EPC STORMWATER REVIEW COMMENTS
IN ORANGE BOXES WITH BLACK TEXT

FINAL DRAINAGE REPORT

FALCON DISTRICT 49 TRANSPORTATION FACILITY, FALCON, CO

PPR2236

D49 TRANSPORTATION CENTER
 SCHOOL DISTRICT NO 49
 EXISTING CONDITION DRAINAGE MAP

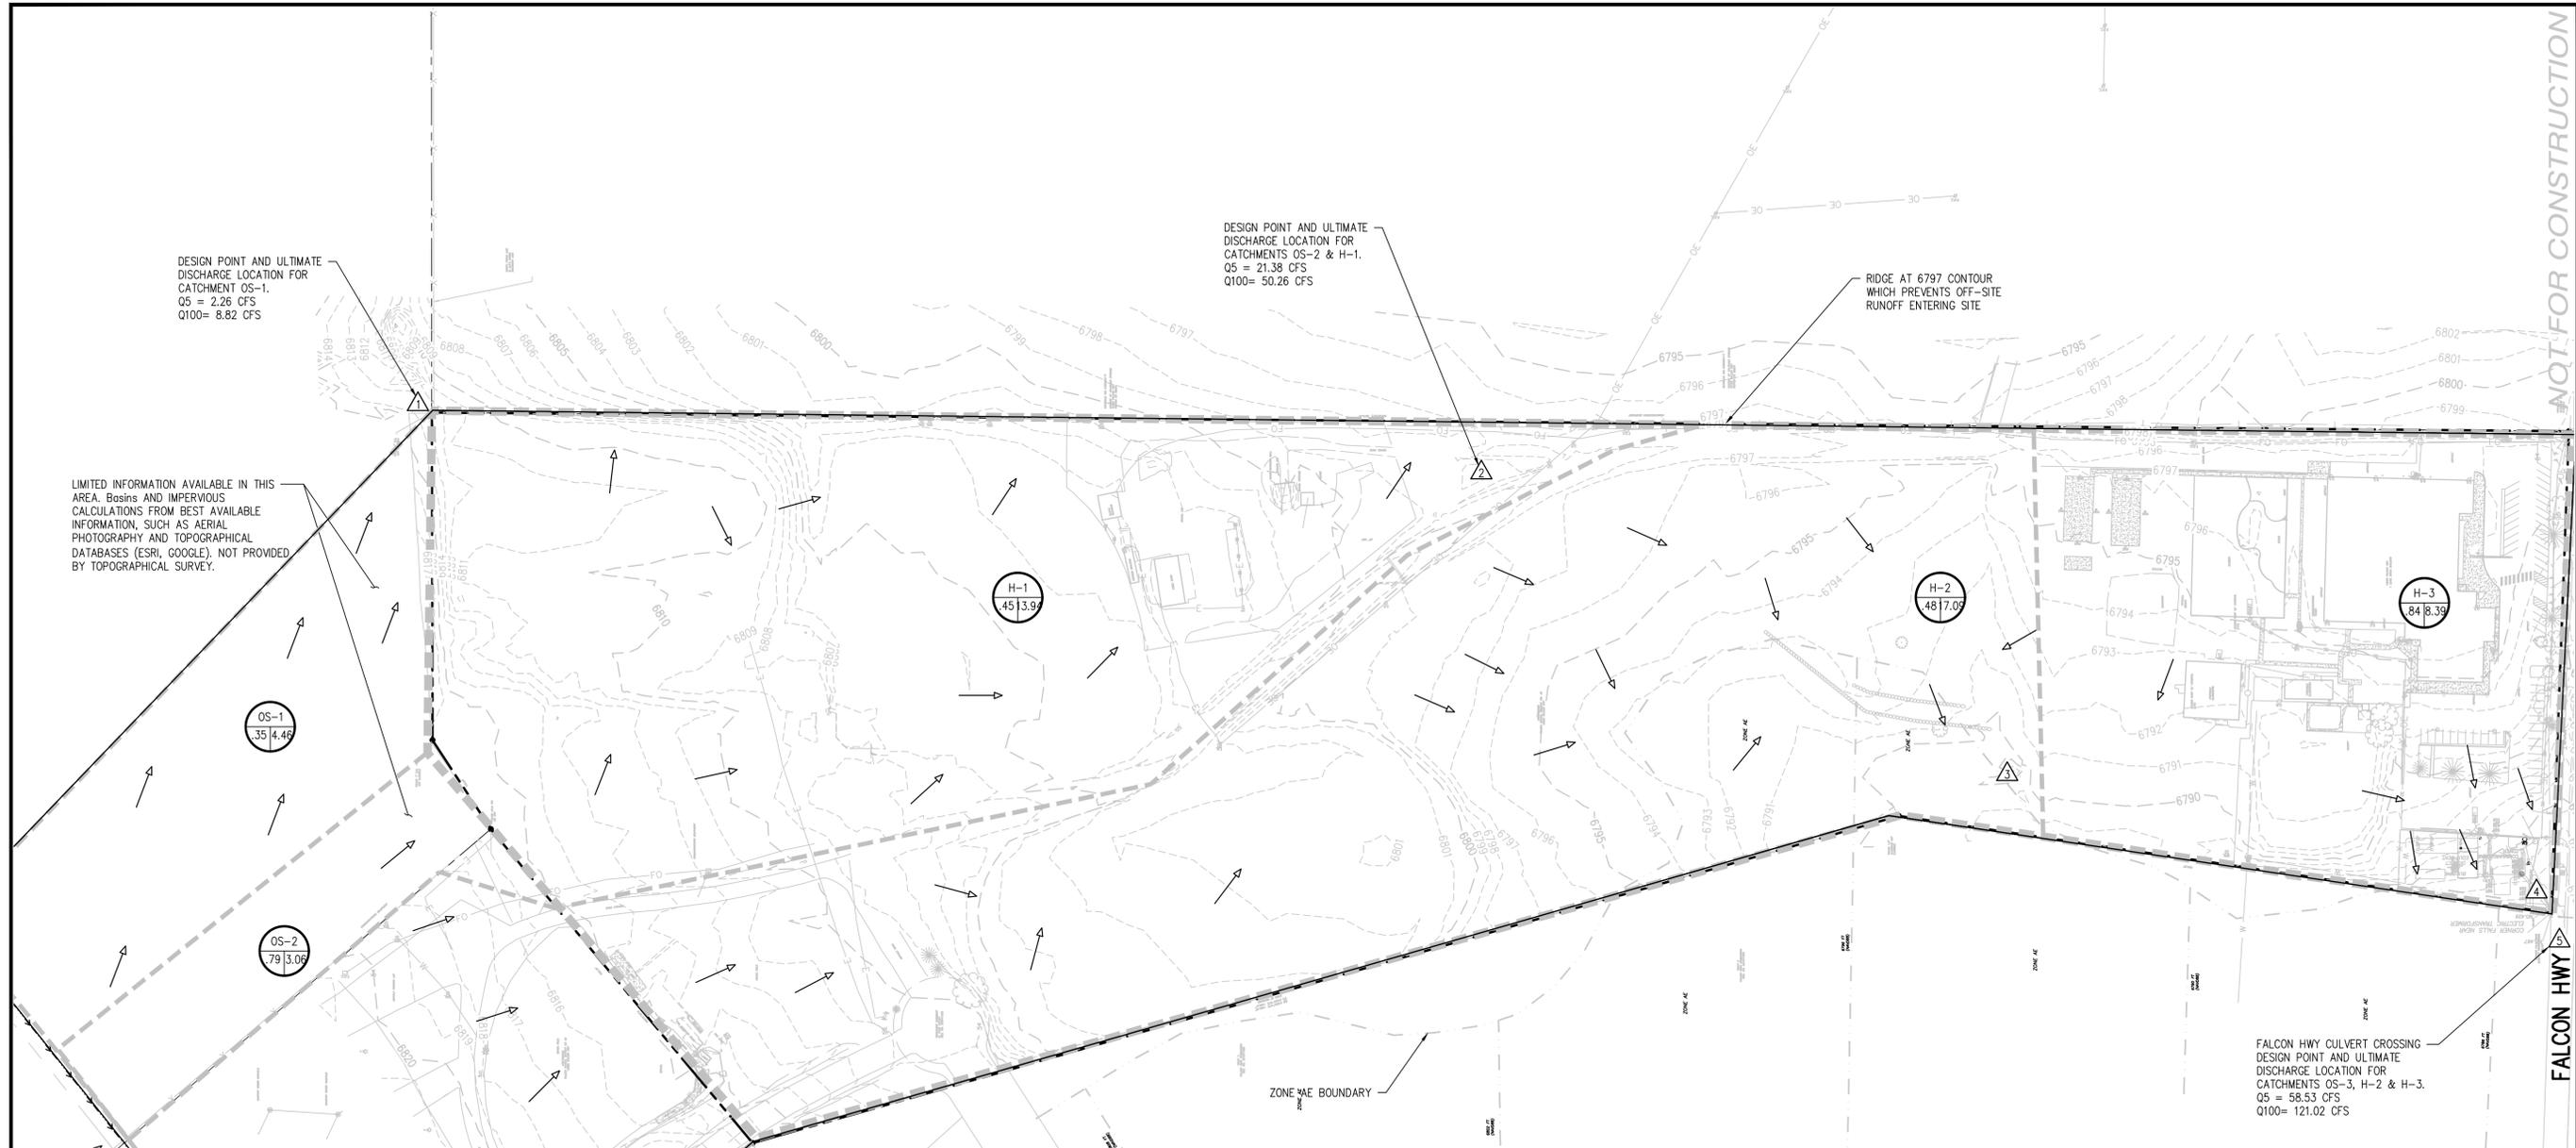
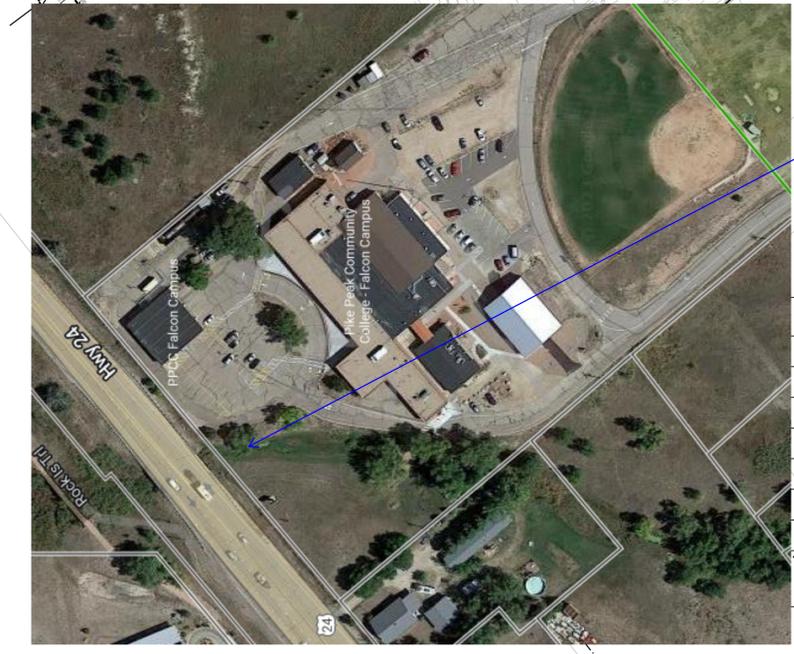
Delineate all offsite basins draining onto the site. Update runoff calculations to include offsite basin. Unresolved. The runoff identified at DP5 is low. This should include all flows not just site flows. See Falcon DBPS for flows crossing Hwy 24 (MT 3) Swingline (MT 2) and Falcon Highway (MT 1)
